East
(and West)
wall framing
plans

East wall
framing plan -

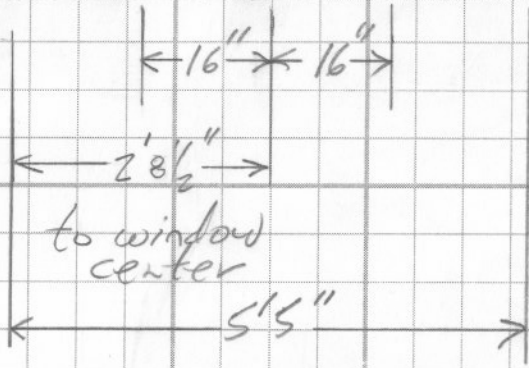
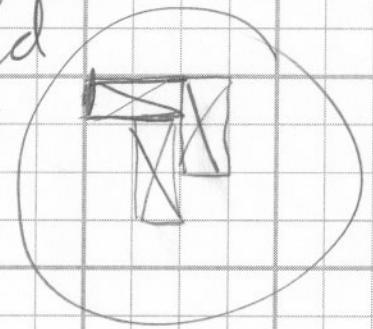
California corners
of 4x4's.
instead

Drawn with 4:12
pitch - ? -
better at 3:12?

3' x 3' window not

← eventually chose 3.5:12
↑
great choice!

South Wall framing plan

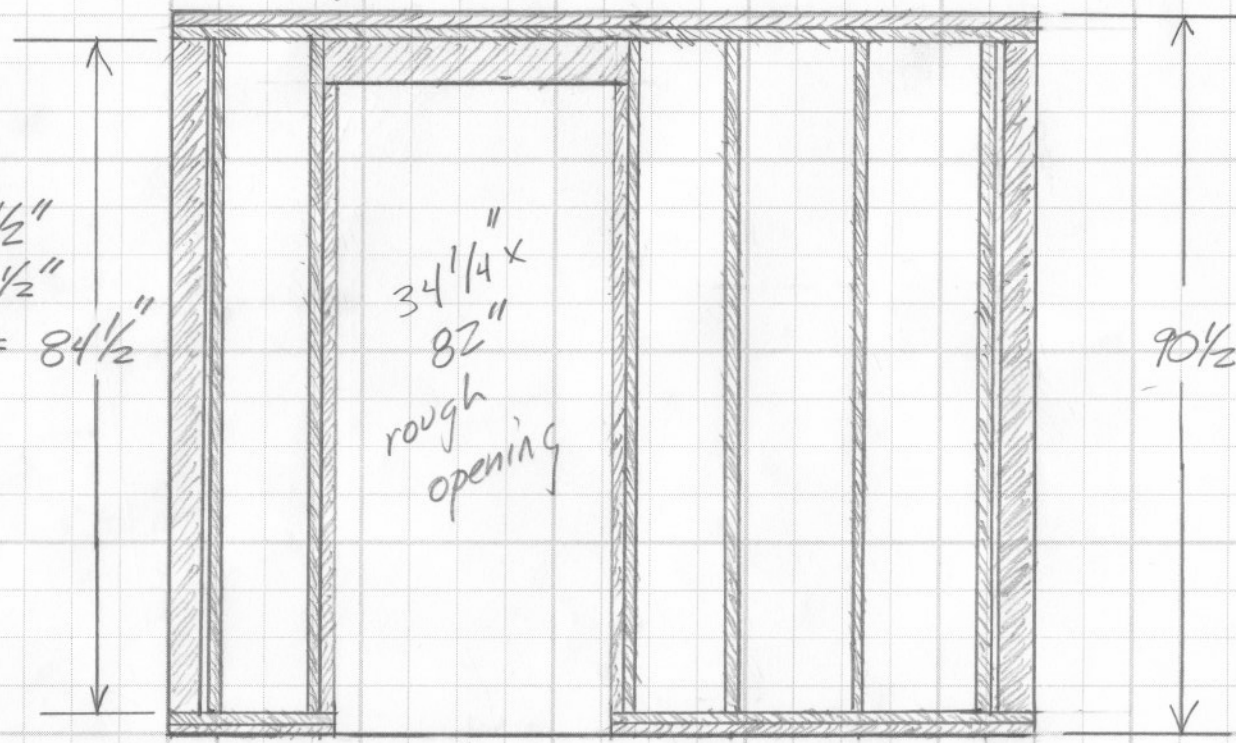
the south wall cannot be made lower
